SHEPHERDS BAY URBAN RENEWAL, MEADOWBANK

STAGE 1 PROJECT APPLICATION (MP 09_0219)

Response to Additional Information Request Preferred Project Report

RESPONSES TO ADDITIONAL INFORMATION REQUEST

APPENDIX 1 - STAGE 1 AREAS:

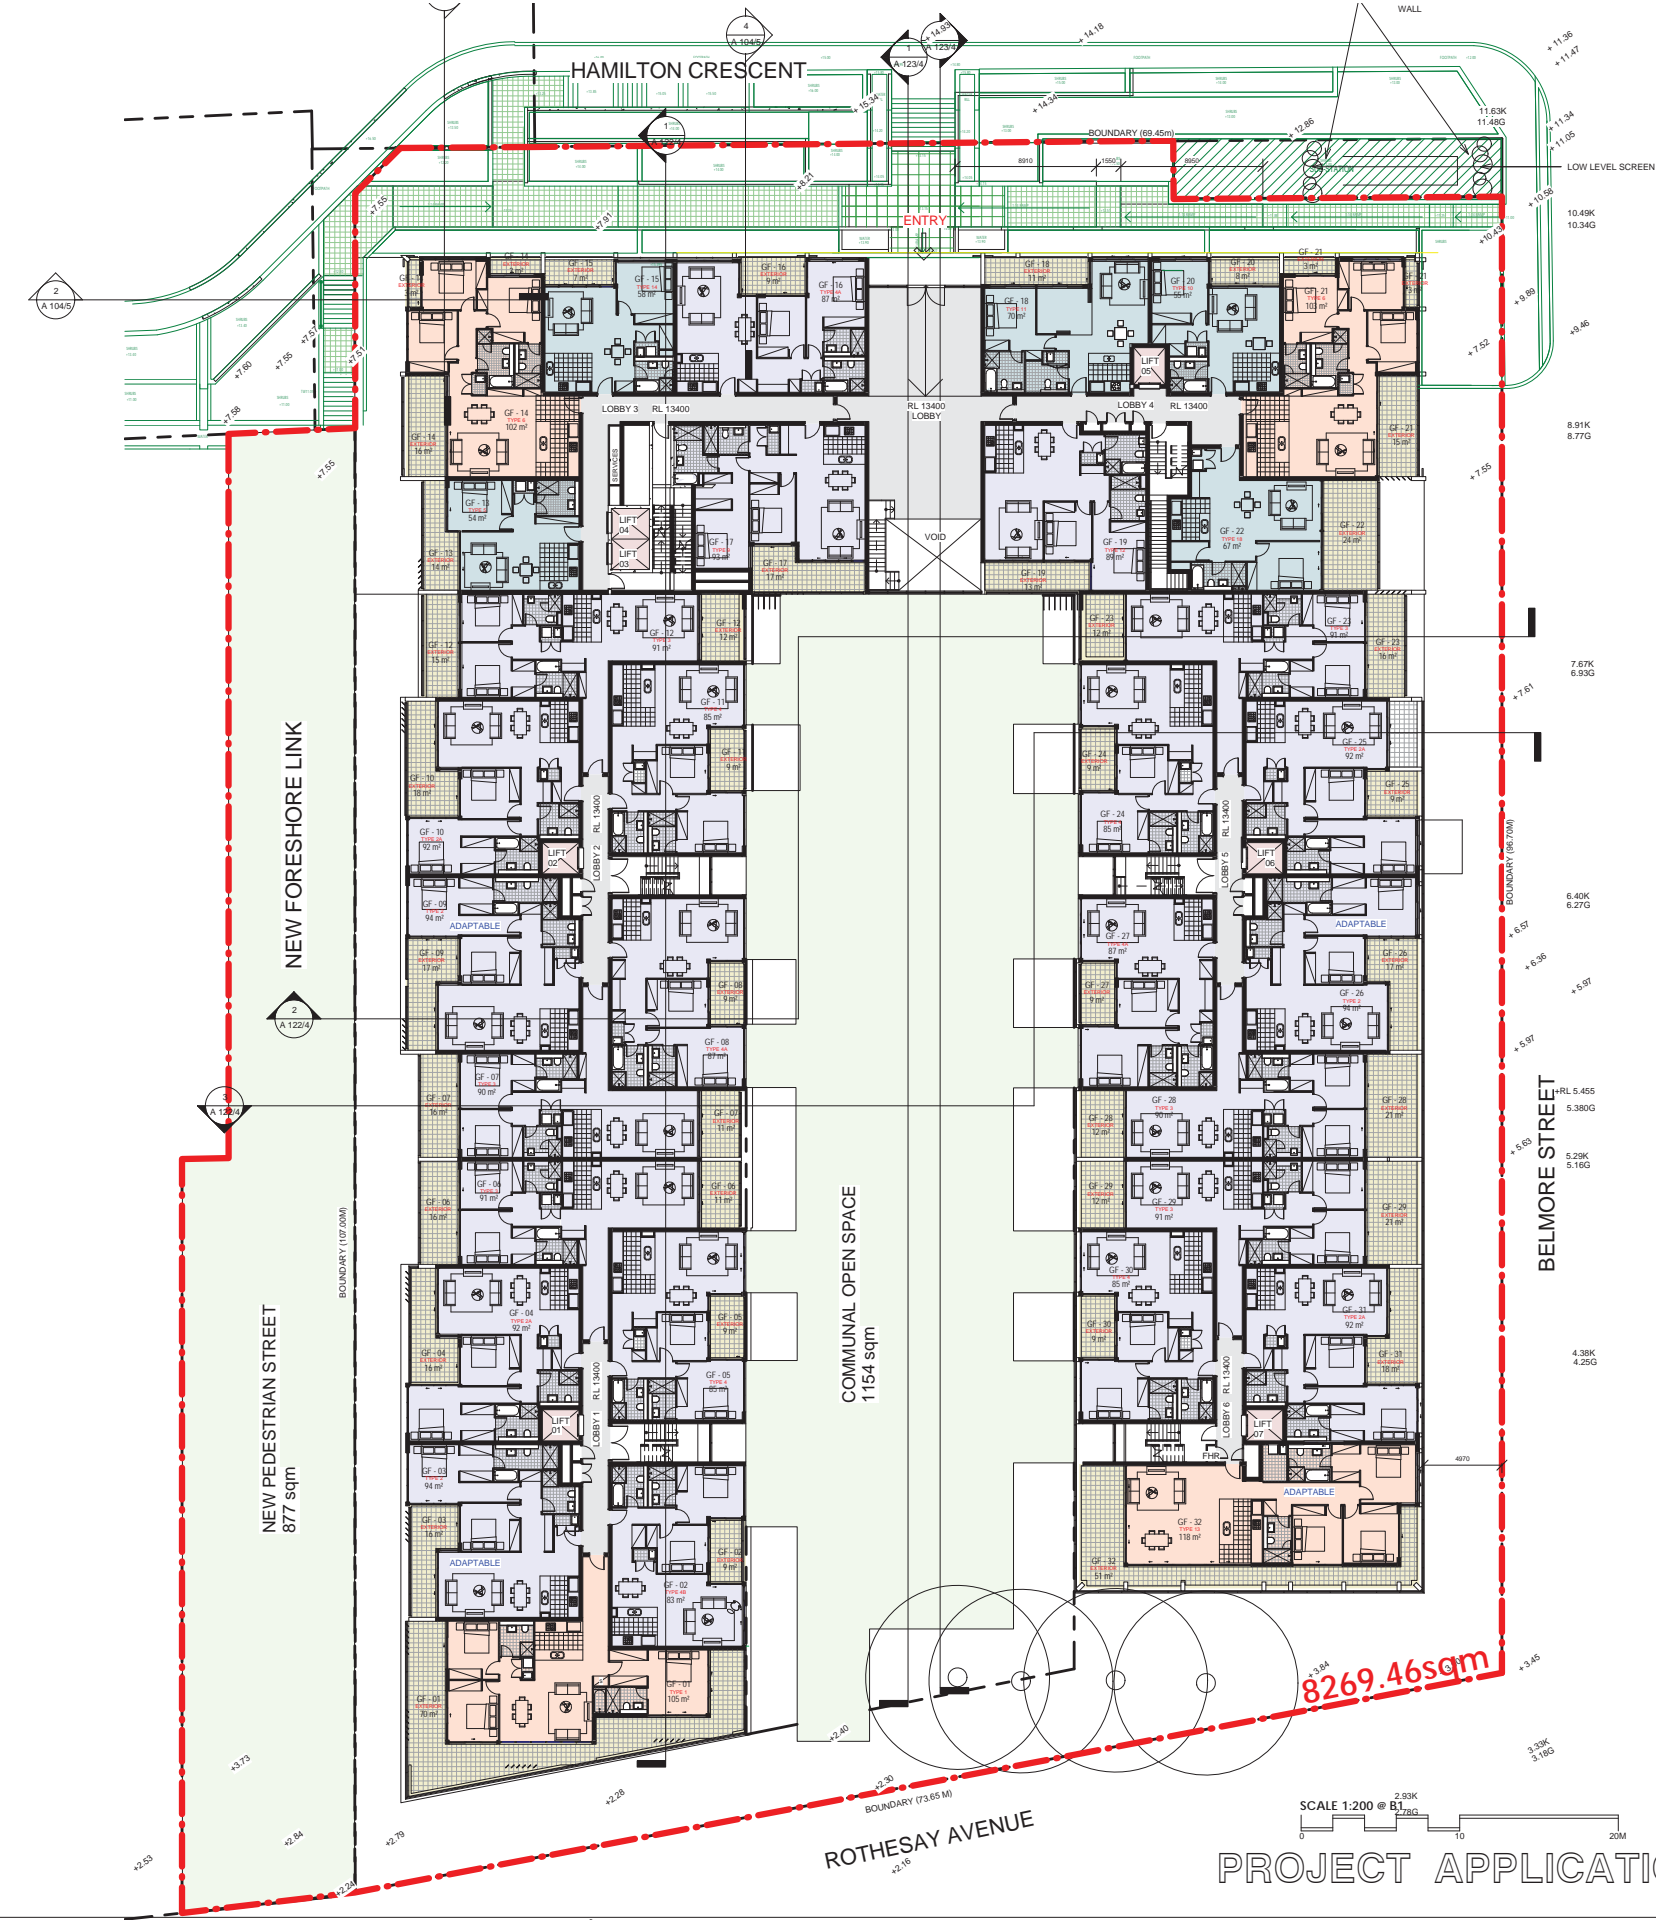
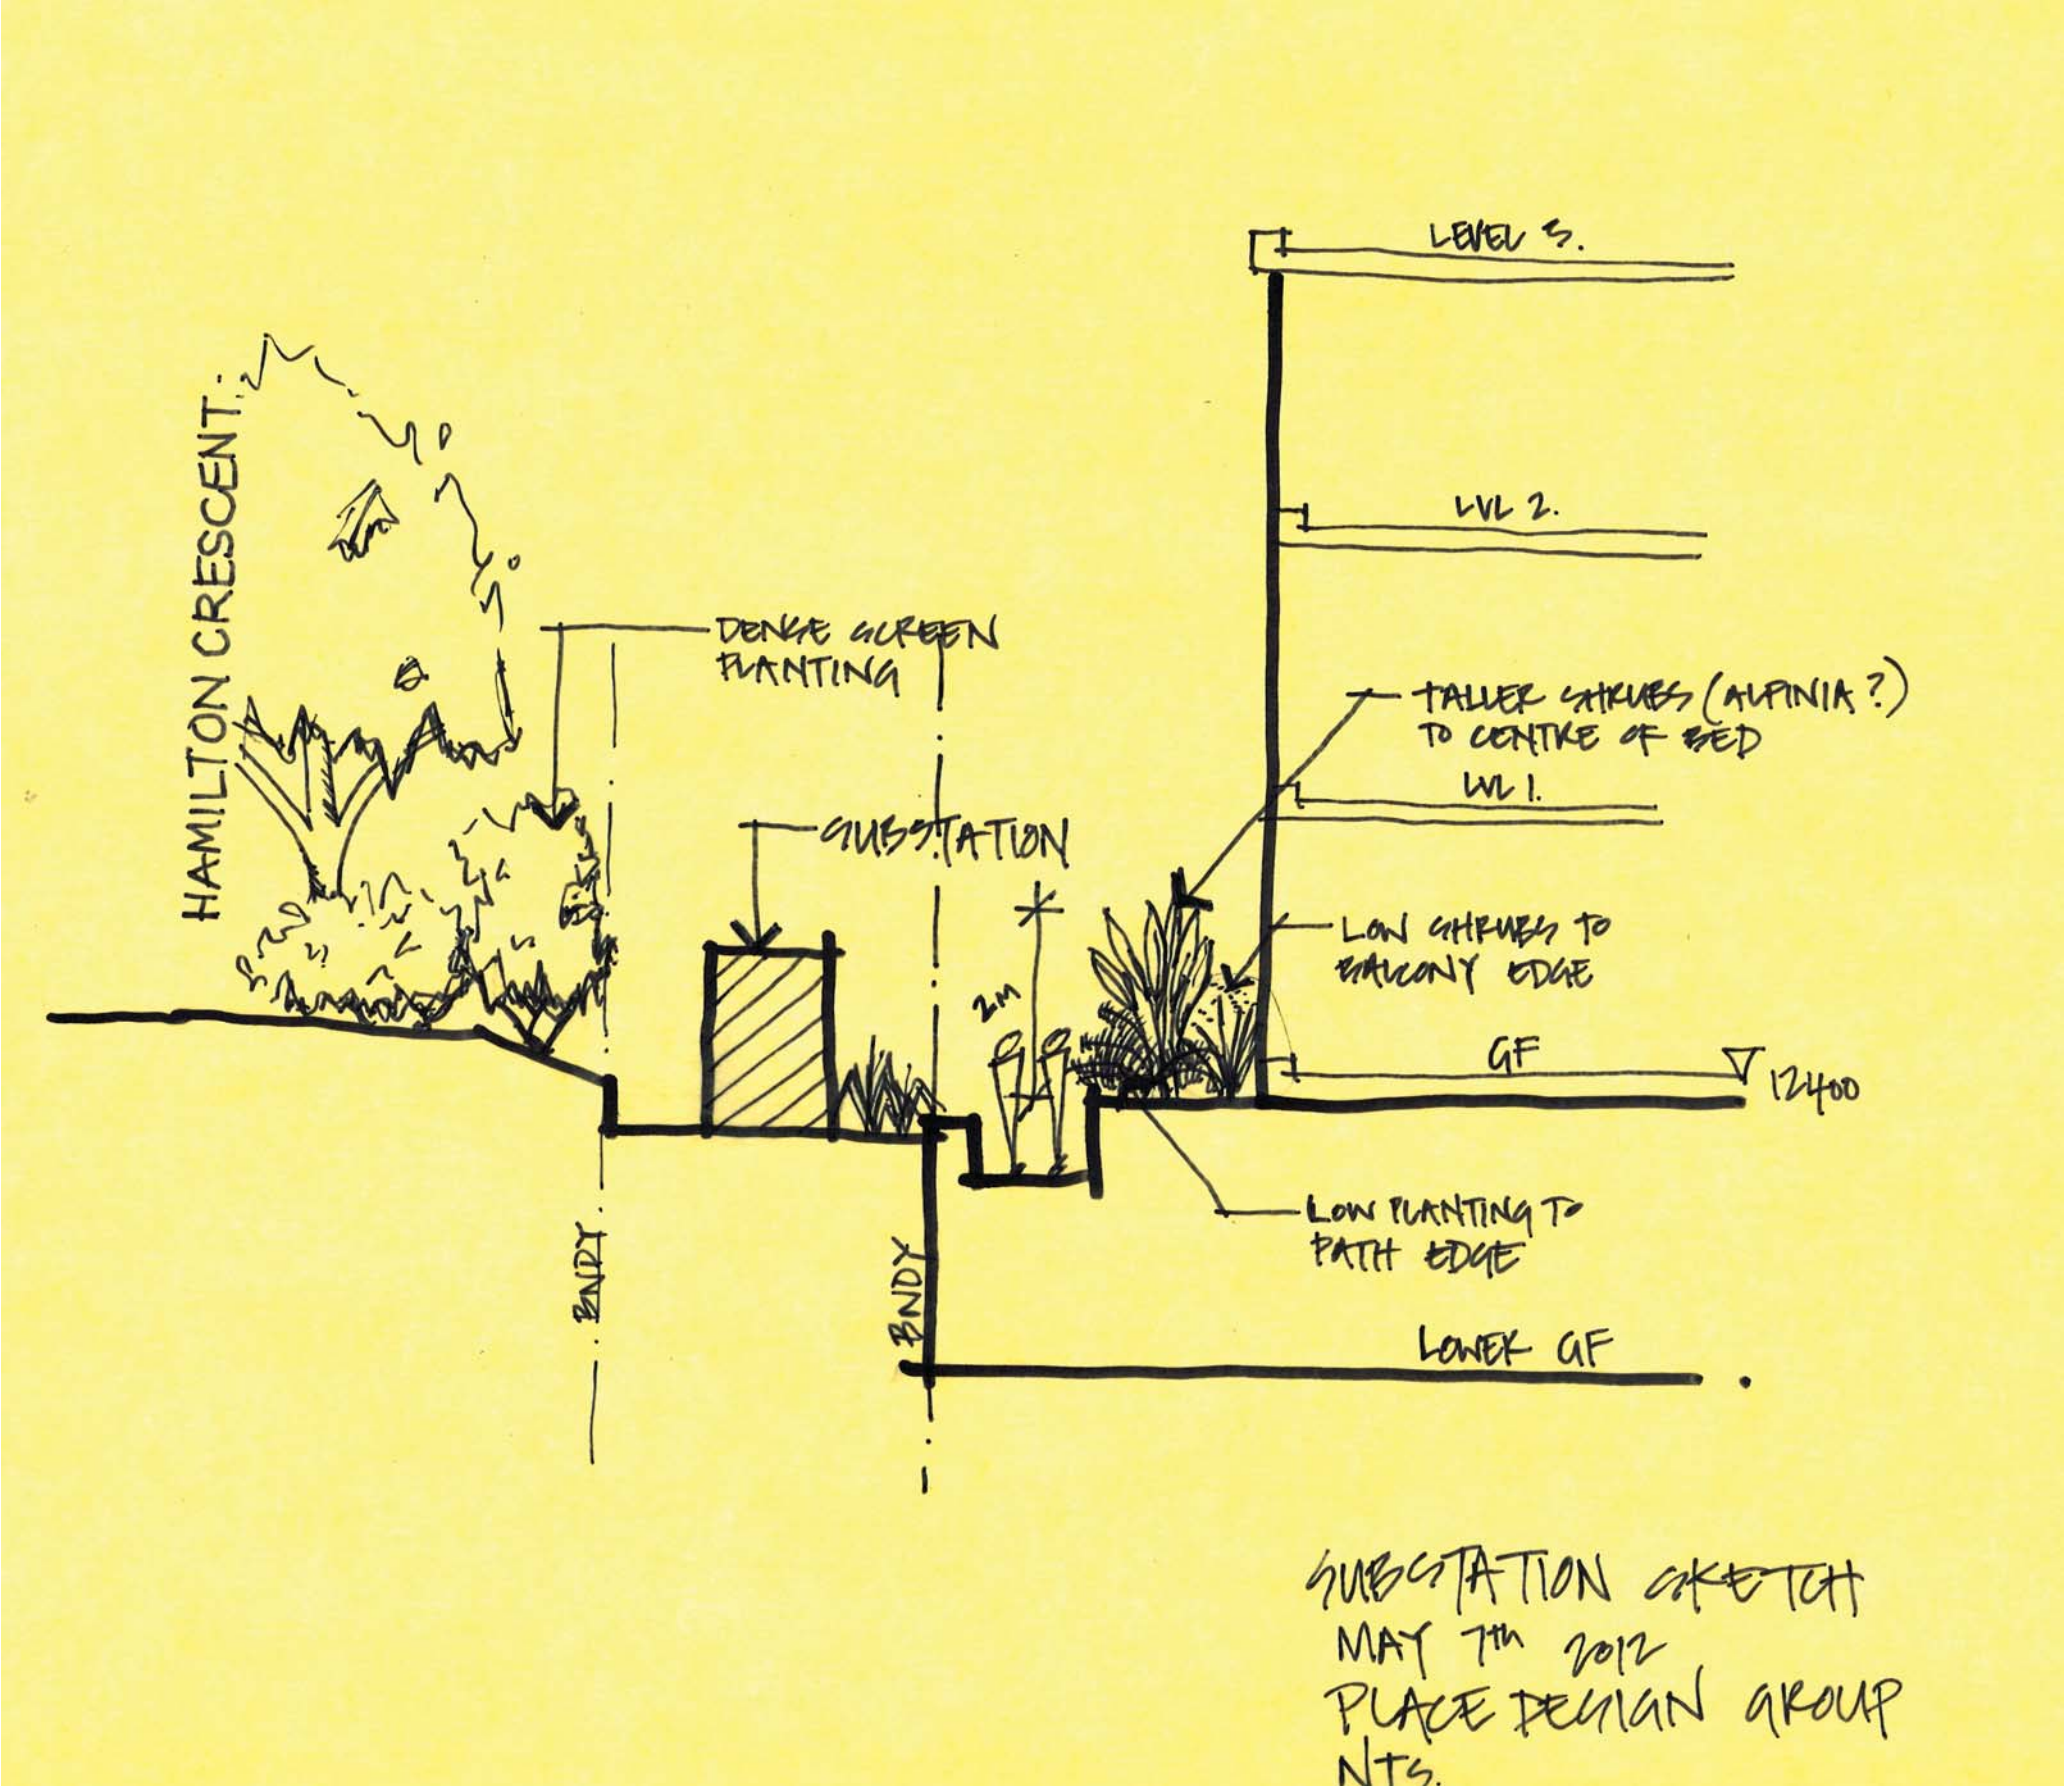
2.	Confirmation on the open space for Stage 1 – page 18 refers to a publicly accessible pedestrian link parkland of 1029.6m2 where as page 20 refers to both 877m2 and 1,029m2 of publicly accessible open space and 1435m2 of communal open space.	It is confirmed the open space areas provided in the Stage 1 Project are: - 877sqm – portion of new pedestrian street, and - 1154sqm communal open space	See Architectural Drawings - A 103-7 Appendix 1
